CITY OF WESTMINSTER			
PLANNING APPLICATIONS SUB COMMITTEE	Date 3 July 2018	Classification For General Release	
Report of Director of Planning		Ward(s) involved Vincent Square	
Subject of Report	Vincent Square Playing Fields Leisure Suite , Vincent Square, London, SW1P 2PW		
Proposal	Demolition of existing extension to the cricket pavilion in Vincent Square and formation of two new flanking extensions, including minor external works to pavilion building.		
Agent	Ptolemy Dean		
On behalf of	Westminster School		
Registered Number	17/07151/FULL	Date amended/ completed	10 August 2017
Date Application Received	10 August 2017		
Historic Building Grade	Unlisted		
Conservation Area	Vincent Square

DRAFT DECISION LETTER

Proposal: Demolition of existing extension to the cricket pavilion in Vincent Square and formation of two new flanking extensions.

Reference: 17/07151/FULL

Proposed Elevations

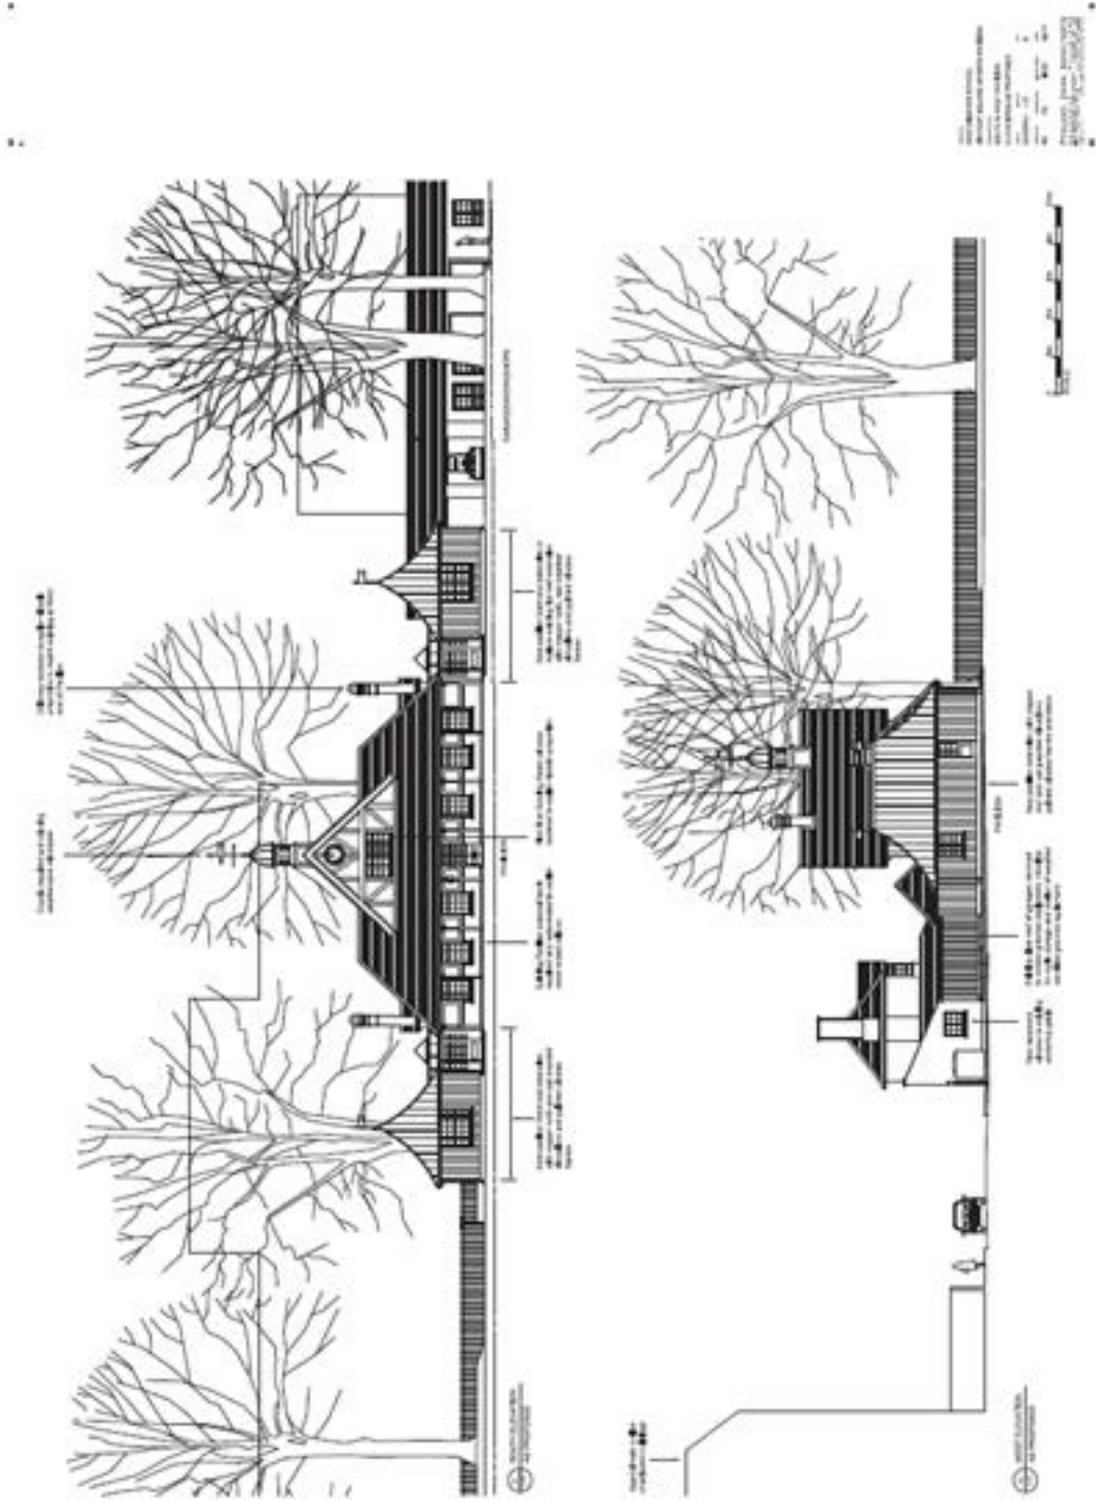
Support Westminster School's wish to improve and extend the Pavilion, subject to the following observations: Residents expressed concern that the 'tent' roofs proposed for the side buildings are unduly high and would prefer a lower profile (but not flat), and with roofing materials in keeping with those on the Pavilion's main roof. i) to reduce the composite bulk of the Pavilion and its side buildings, especially when viewed from the 'RHS' side of the Square; and ii) to minimise, to the extent possible, the impact on residents who currently enjoy views of the playing fields from house and flats on that side of the Square. Concerned that the proposal appears to reduce the already restricted parking space for visitors within the site and would be concerned about any proposal which might involve any parking provision being made on Vincent Square itself, for example, for visiting school buses and associated commercial vehicles.

- Proposed extension is out of scale and character.
- Roof materials are out of character.
- Extension should be confined to the east where the existing extension is.

Objections have been received from residents in properties fronting the north side of Vincent Square, expressing concerns in relation to the design, height and materials of the extensions and impact on views. With regards to materials, copper is a traditional material and appropriate in this context. The existing cupola to the Pavilion may be in copper, although has been painted and the applicants cannot confirm this until repair works are undertaken. The applicant has provided a number of images of precedents for copper roofs in proximity to the site.

The residents' desire for roofs of a lower profile and with roofing materials in keeping with those on the Pavilion's main roof is noted. The applicants were also asked to explore other options but found that using clay tiles at the minimum pitch required would

not lower the overall ridge height of the extensions and may increase the overall bulk of the extensions. Flat roofs or other materials are unlikely to be appropriate in this location.

Overall, it is considered the extensions would not have a significant or harmful impact when viewed from the objectors' properties, particularly as the visual impact of the pavilion is partially contained in views from this side of the Square due to the boundary walls, storage and the taller Lodge building. Further, as set out above, the proposed extensions will also help screen car parking and storage areas adjacent to the existing extension, which are currently visible and unsightly.

Proposed Ground Floor Plan

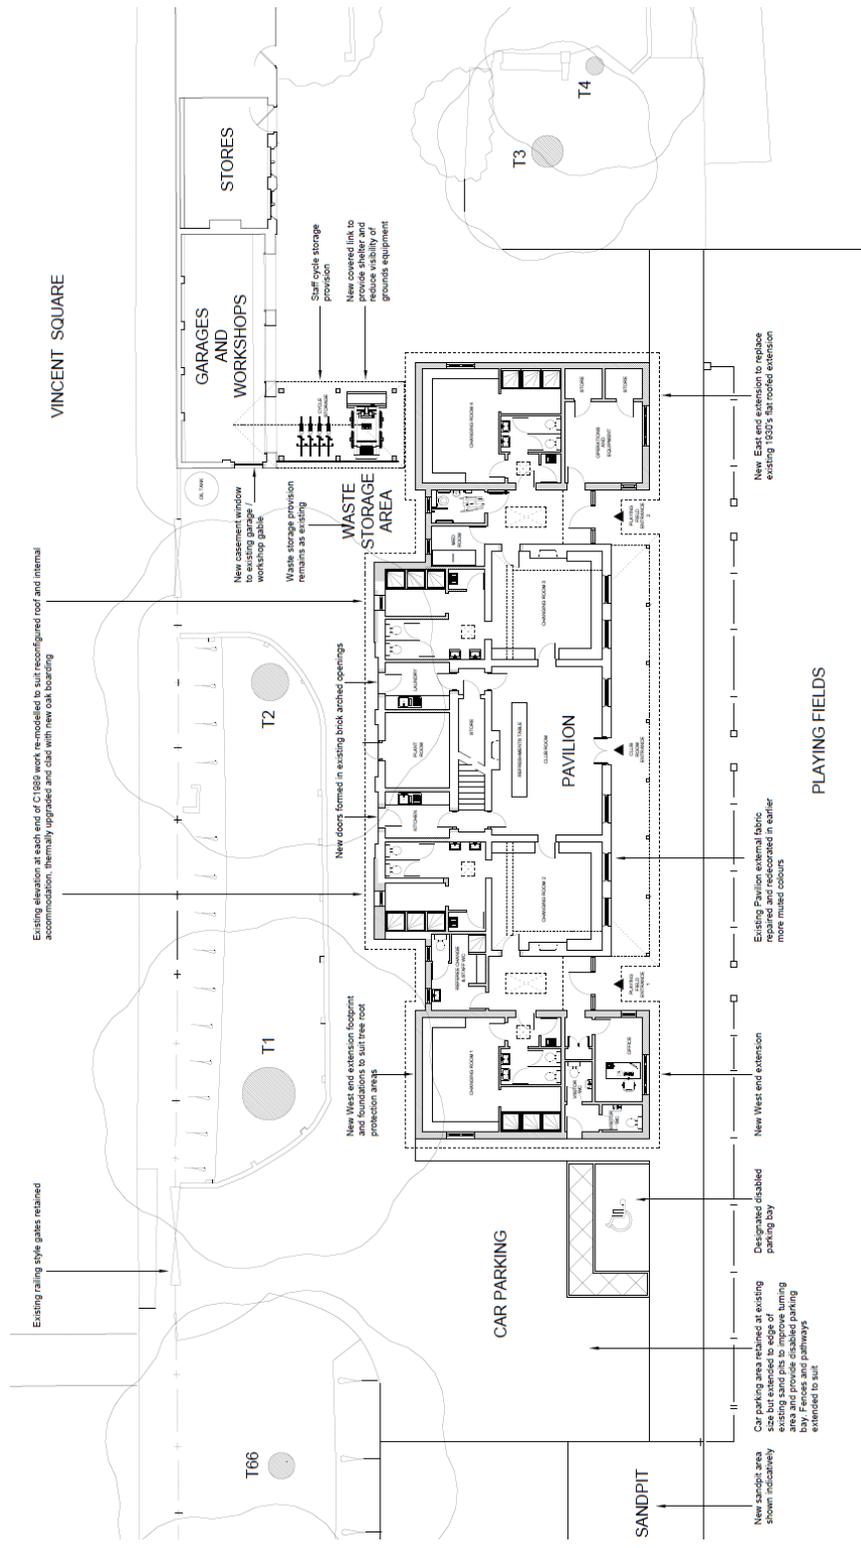
Existing elevation at each end of C1989 work re-modelled to suit reconfigured roof and internal accommodation, thermally upgraded and clad with new oak boarding

New casement window for larger working gable
Waste storage provision remains as existing

Staff cycle storage provision
New covered link to reduce visibility of grounds equipment

New doors formed in existing brick arched openings

New West end extension footprint and foundations to suit tree root protection steps

New East end extension to replace existing 1980's flat roofed extension

Existing Pavilion external fabric repaired and redecorated in earlier more muted colours

Designated disabled parking bay

Car parking area reduced at existing size but extended to edge of existing sand pit to improve turning area and provide disabled parking and wheelchair access pathways extended to suit
